***Partial Revisions to the Application Document for Approval to Amend the Implementation Plan Regarding the Handling of ALPS Treated Water [Overview]**

April 28, 2022

Tokyo Electric Power Company Holdings, Inc.

* This application is to make a partial revision to the application for amendment related to design, facilities and dose assessment, submitted in December 2021. An additional revision on other parts in the implementation plan will be submitted at a later stage for NRA's examination.

2-2. ALPS Treated Water Dilution/Discharge Facility (Measurement/Confirmation Facility)

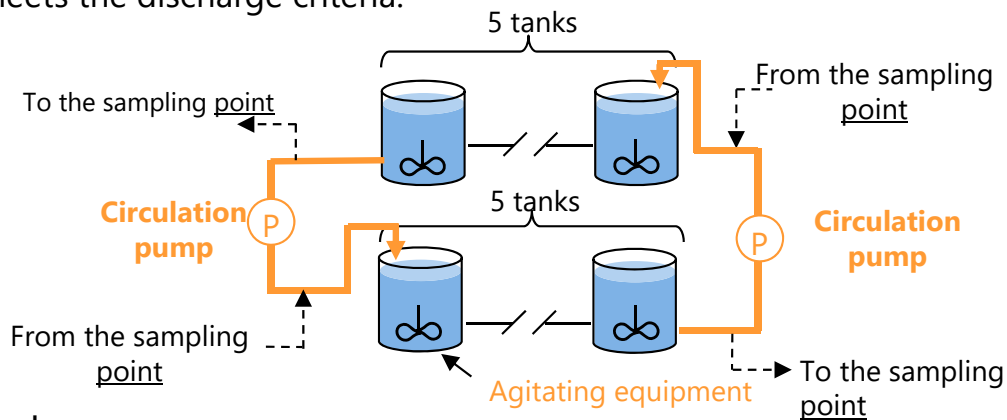
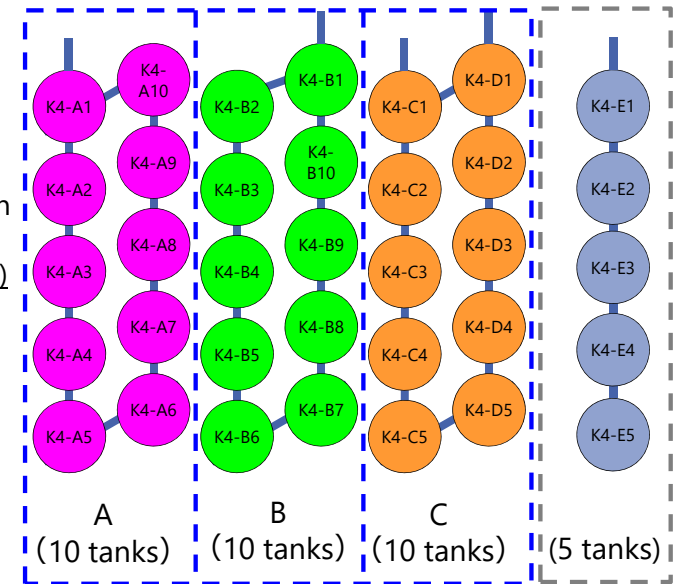
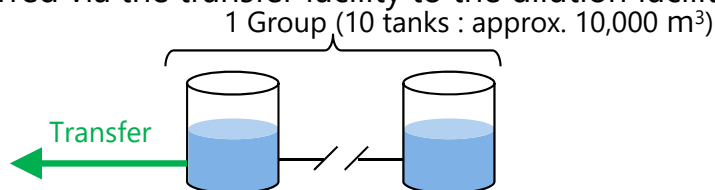
- K4 area tanks (total : approx. 30,000 m³) will be used as measurement and confirmation tanks. 10 tanks of each will be taken from groups A, B, and C (each tank has a capacity of around 1,000 m³).
- Each tank group is charged with processes ① through ③ in rotation, and in the ② Measuring/confirmation process, water that has been made homogenized through circulation and agitating will be sampled and analyzed.

2-3. ALPS Treated Water Dilution/Discharge Facility (Transfer Facility)

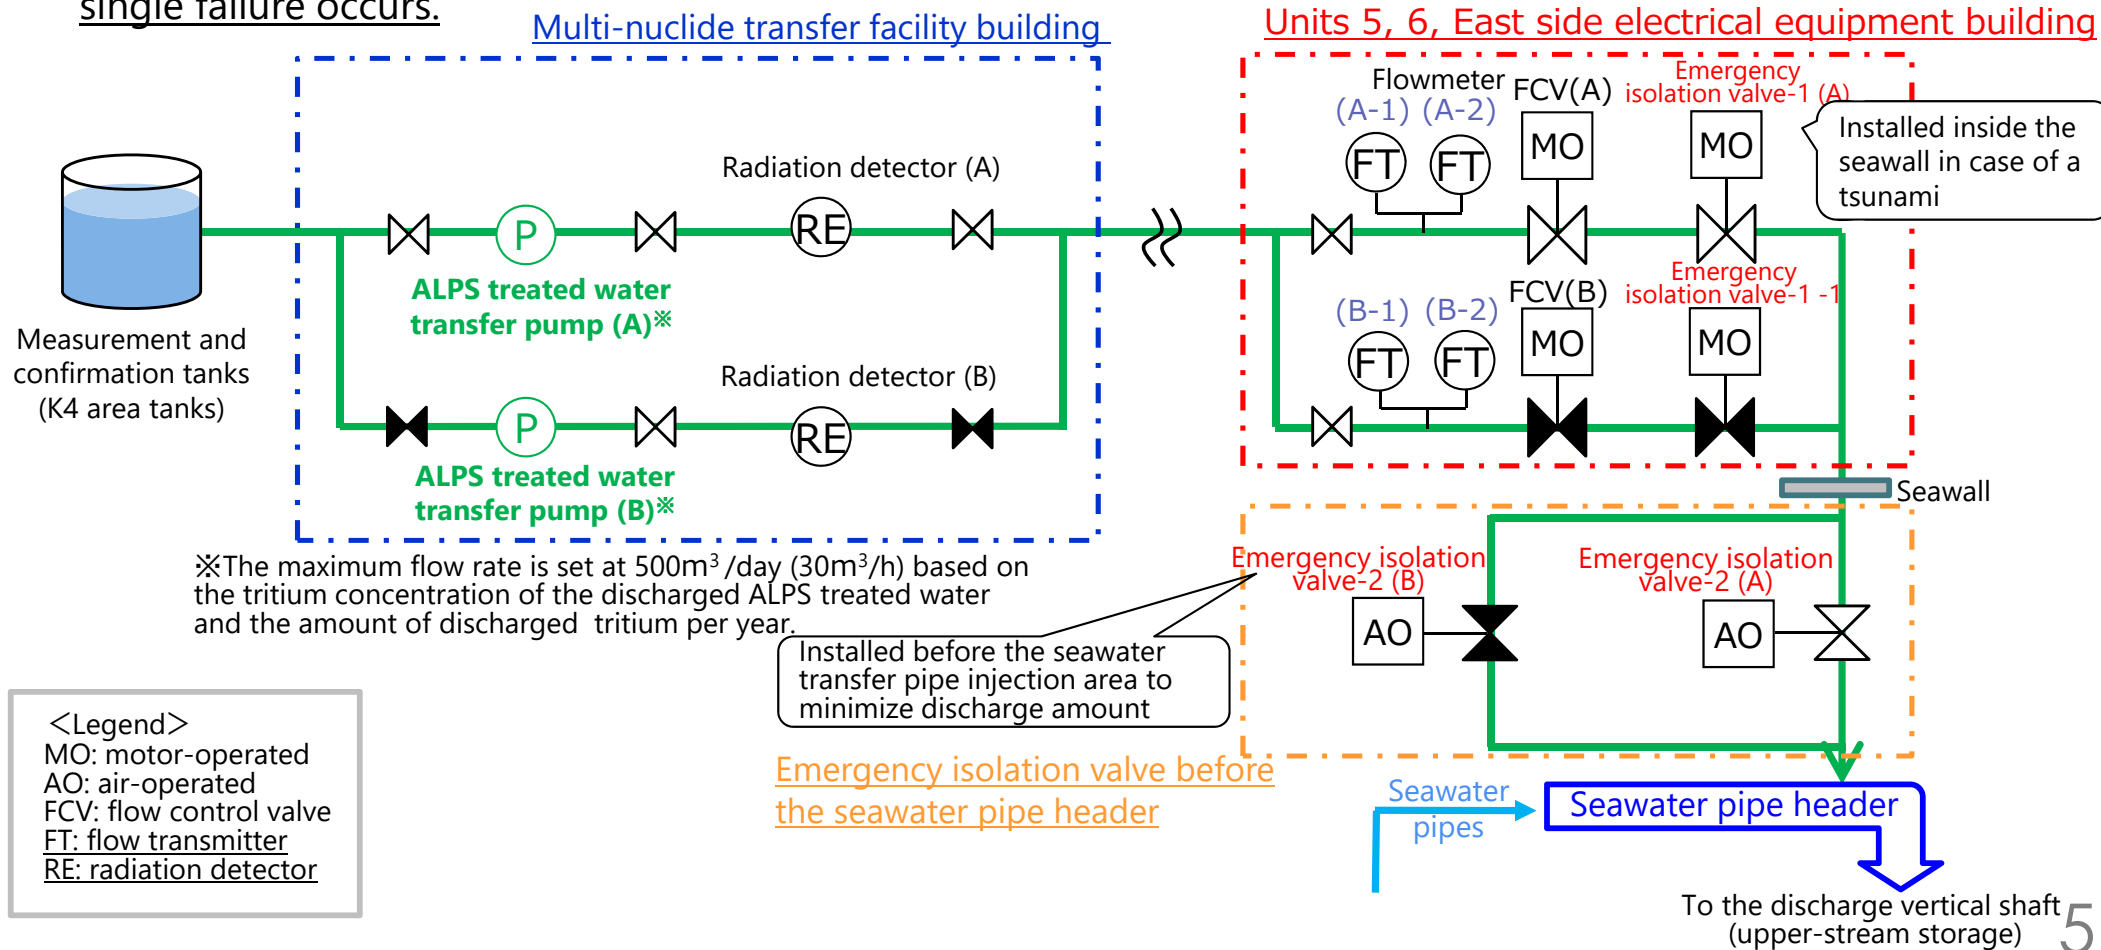
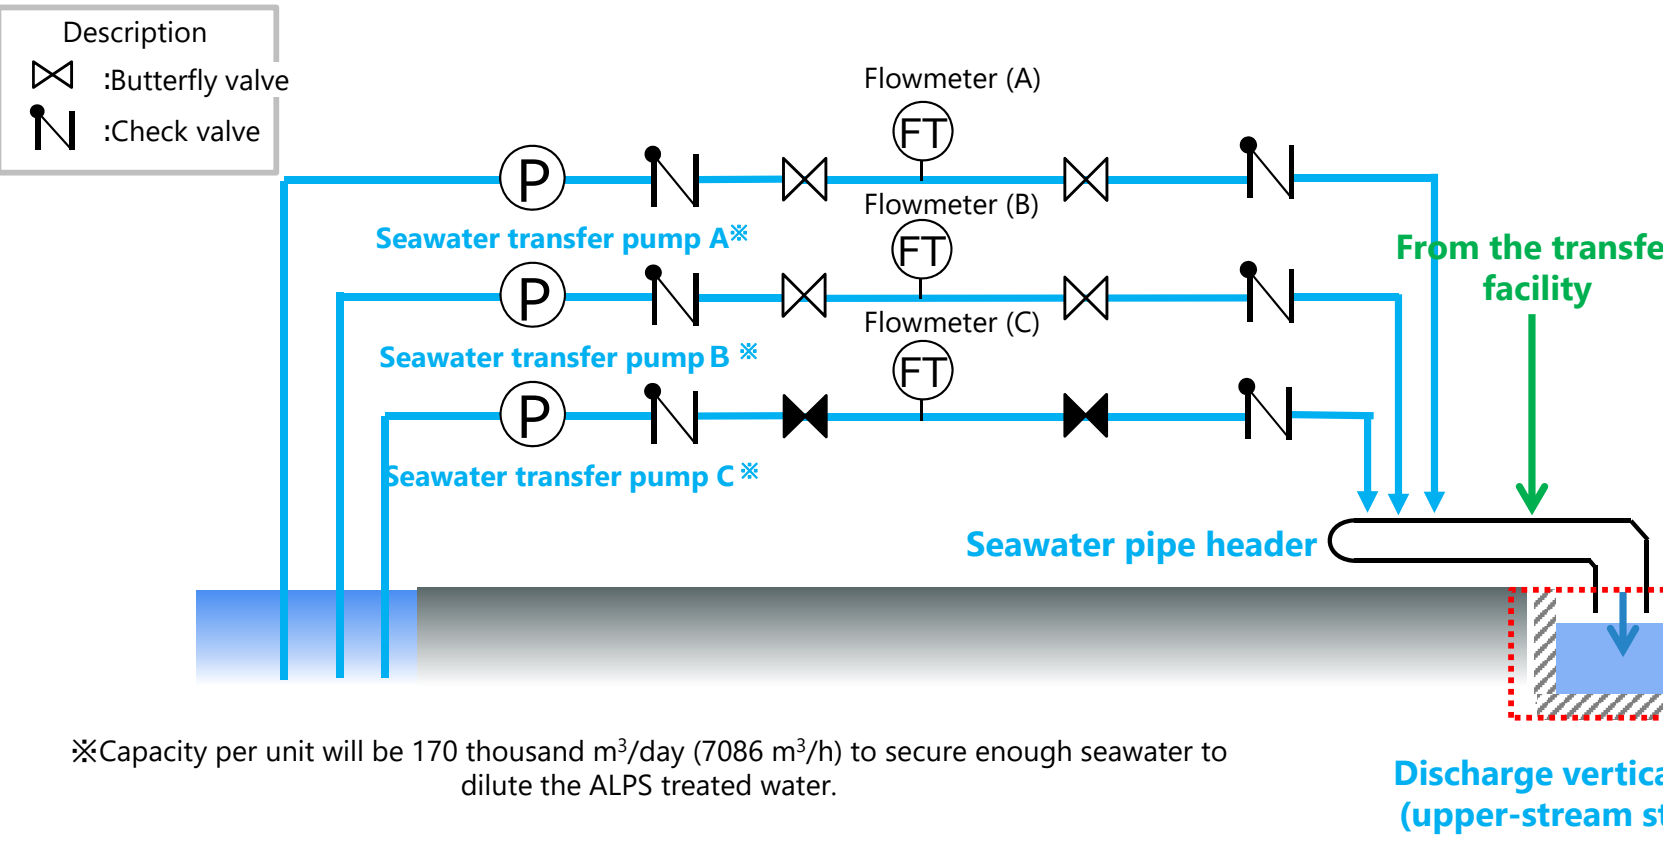
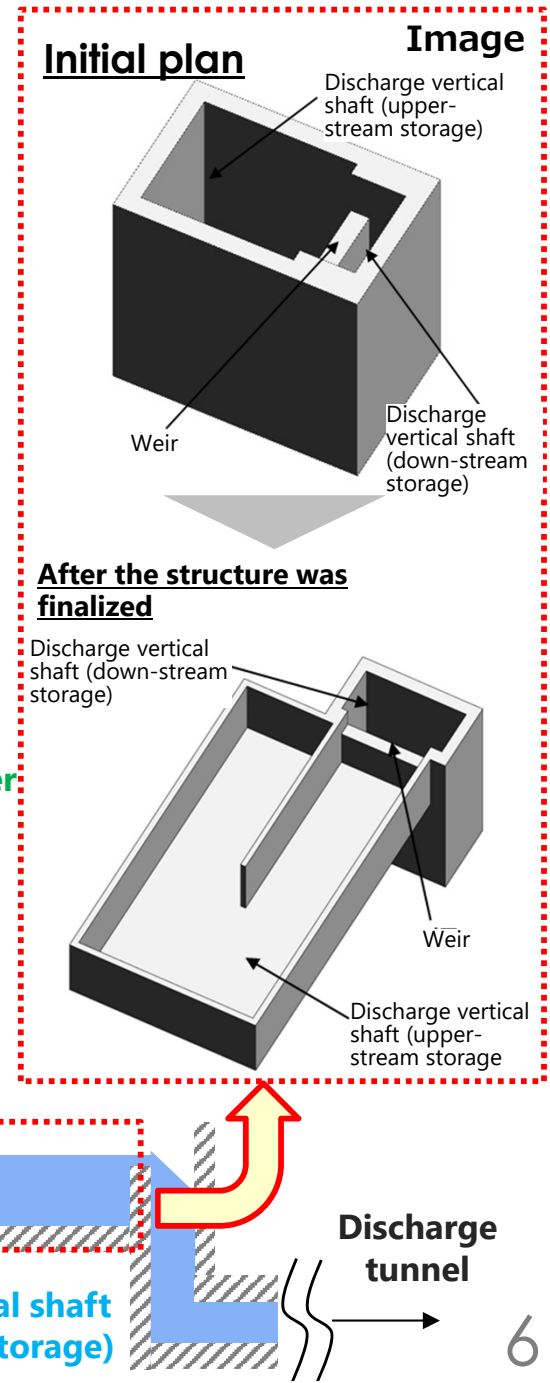
- The transfer facility is comprised of the ALPS treated water transfer pumps, transfer pipes and emergency isolation valves.
- ALPS treated water transfer pump is comprised of two units, the operating unit and the reserve. It transfers the ALPS treated water from the measurement and confirmation tank to the dilution facility.
- Two emergency isolation valves will be installed, one before the seawater pipe header to be able to stop transfer swiftly in an emergency and another inside the seawall, as a tsunami measure.
- The ALPS treated water flow meter will be duplexed to ensure flow can be accurately measured even when a single failure occurs.

*The maximum flow rate is set at 500m³/day (30m³/h) based on the tritium concentration of the discharged ALPS treated water and the amount of discharged tritium per year.

4-1. Major Changes and additions

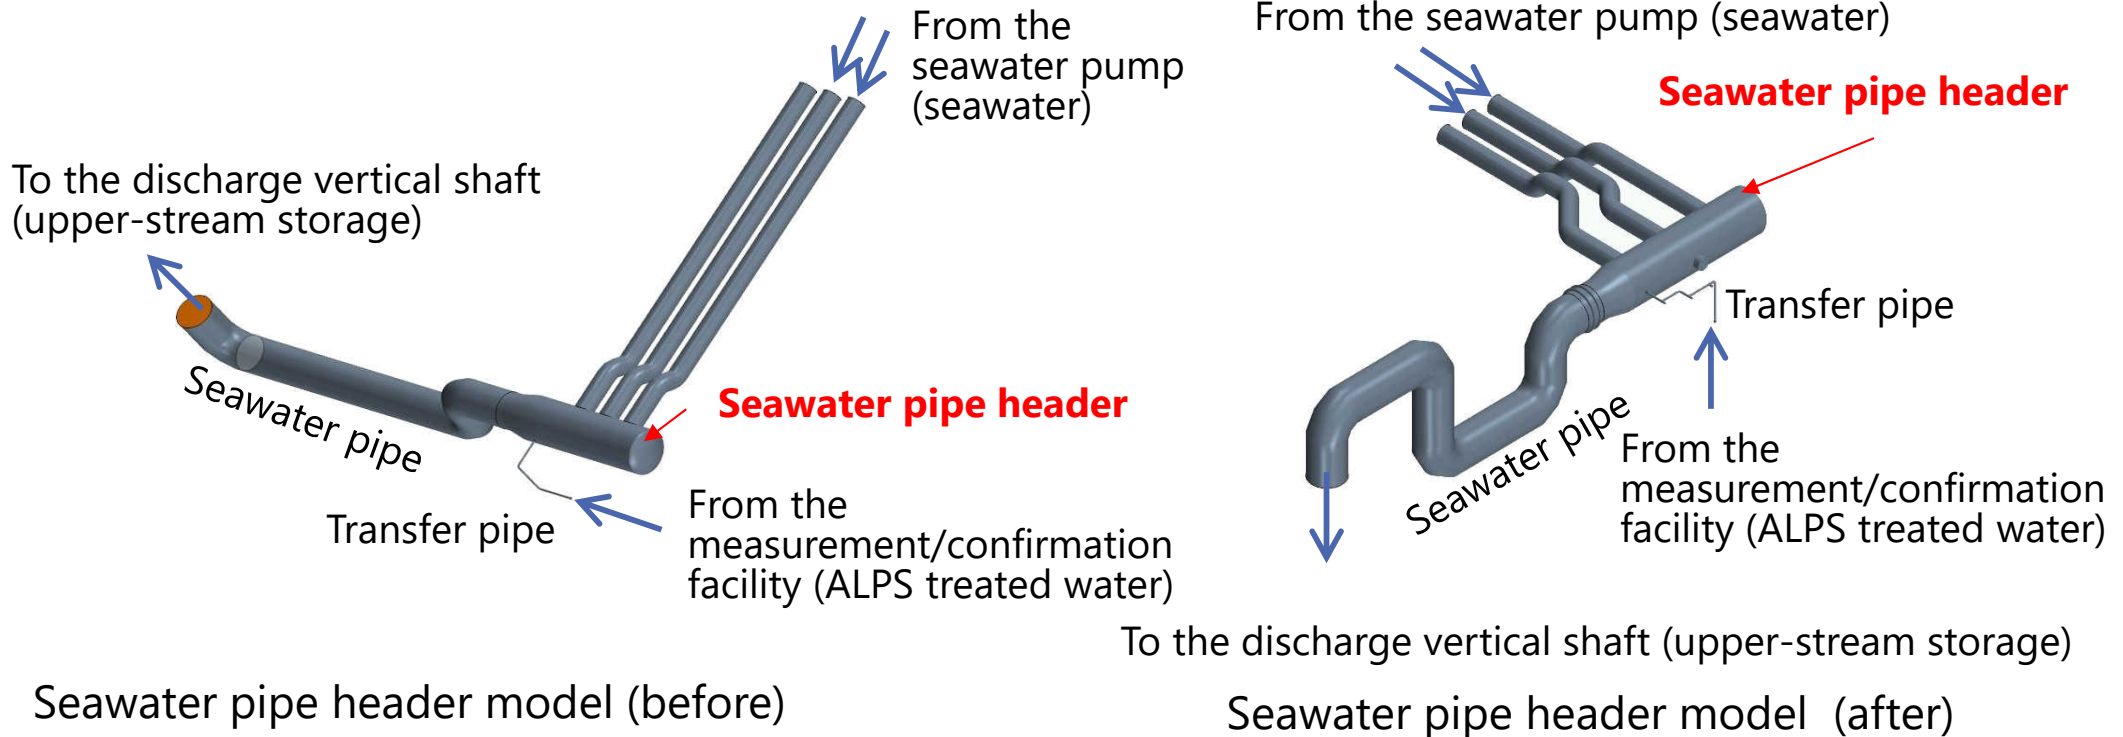
- As the structural design of the discharge vertical shaft (upper-stream storage) was finalized, the shape of the seawater pipe was also altered. The mixing and dilution assessment using the analysis code was updated accordingly. As before the design changed, it was confirmed that water could be diluted by 100 times in the seawater pipes.

- Seawater intake method / discharge method of ALPS treated water after dilution
 - A partition weir will be installed to separate the Unit 5 and 6 open conduit from the station harbor on the side of the Units 1-4 open conduit intake, and parts of the north breakwater permeation prevention works on the north side will be modified (partly removed) to create a partition for taking seawater for dilution from outside of the station harbor on the north side of the Units 5 and 6 discharge outlet. This will reduce the amount of seawater with relatively high radioactive materials concentration flowing in from the side of the Units 1-4 open conduit intake channel (See diagram in slide 8).

4-2. Major Changes and additions

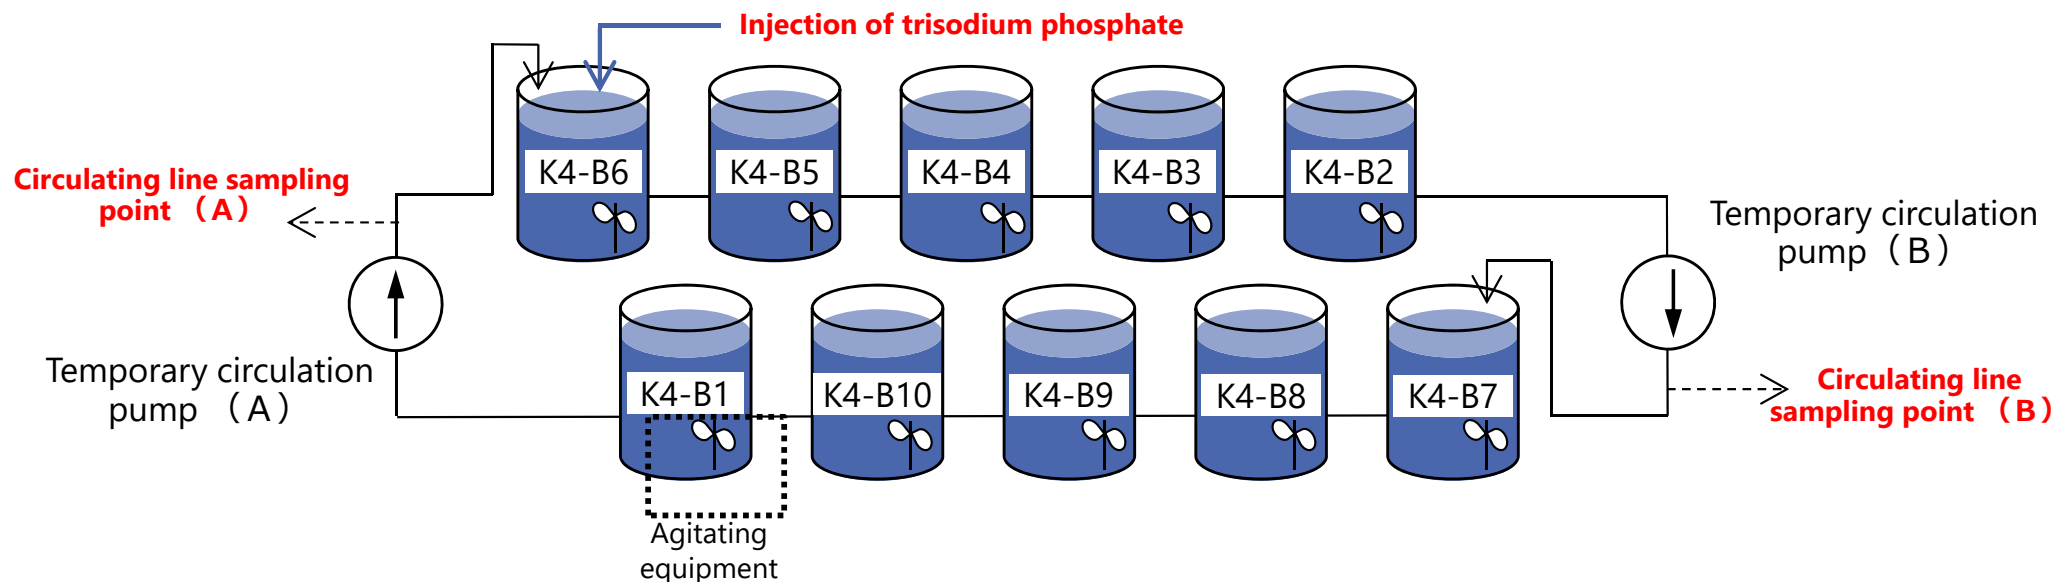
- To ensure the radioactive concentration of ALPS treated water before discharge into the sea can be made homogenized, a agitating demonstration test for one tank with trisodium phosphate as the reagent was conducted in November 2021. While A circulation agitating demonstration test connecting 10 tanks (see diagram below) was conducted in February 2022. These tests confirmed that the concentrations can be made homogenized with this equipment configuration for 10 tanks.
- The application was amended to include that based on these results, the actual equipment configuration will be set up similarly to the demonstration test and the circulation and agitating time will be set appropriately (enough for the full tank amount to circulate the 10 tanks twice at the start of operation).

4-3. Major Changes and additions

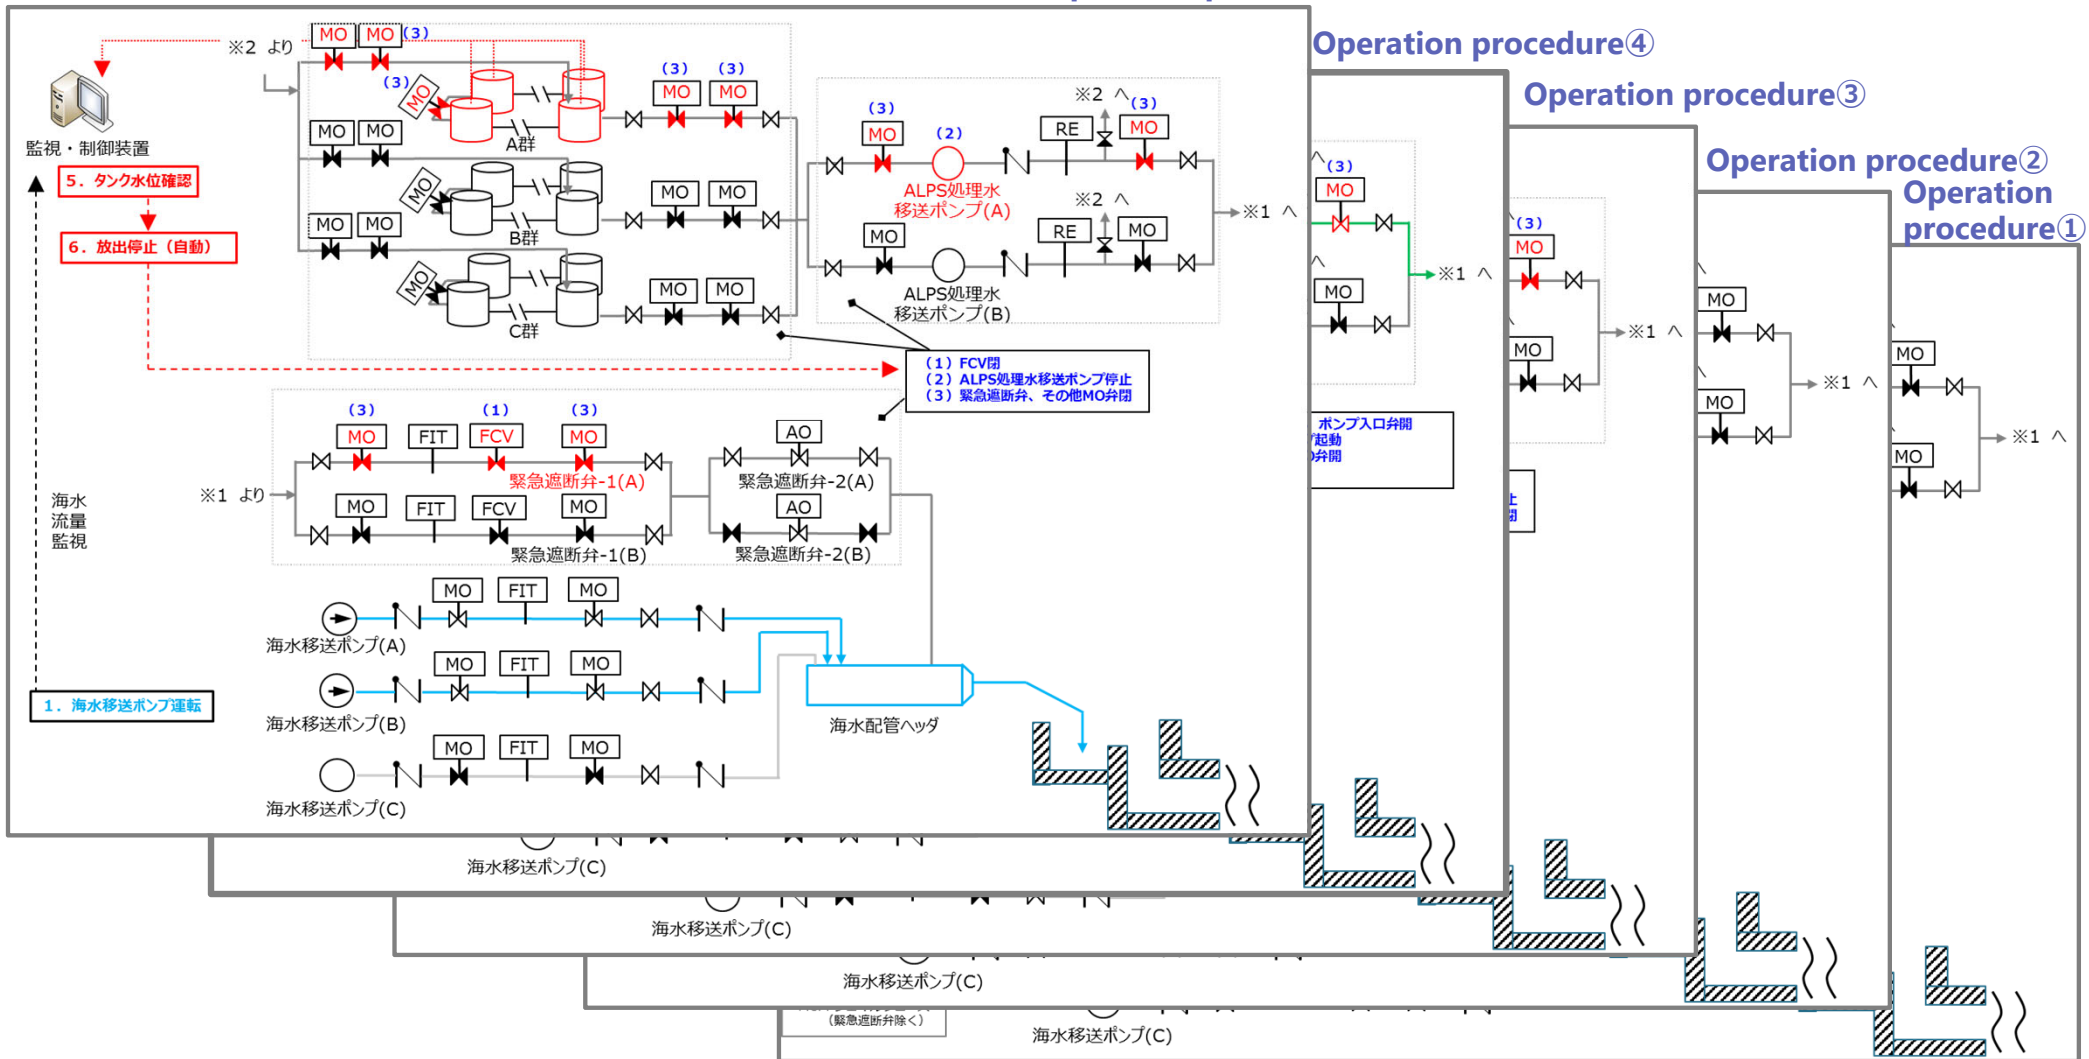
- Operation management for ALPS treated water dilution and discharge facility
 - Added the operation procedures for the measuring and confirmation step and the discharge step in the ALPS treated water dilution and discharge facility, and the appropriateness of design and operation of the ALPS treated water dilution and discharge facility.
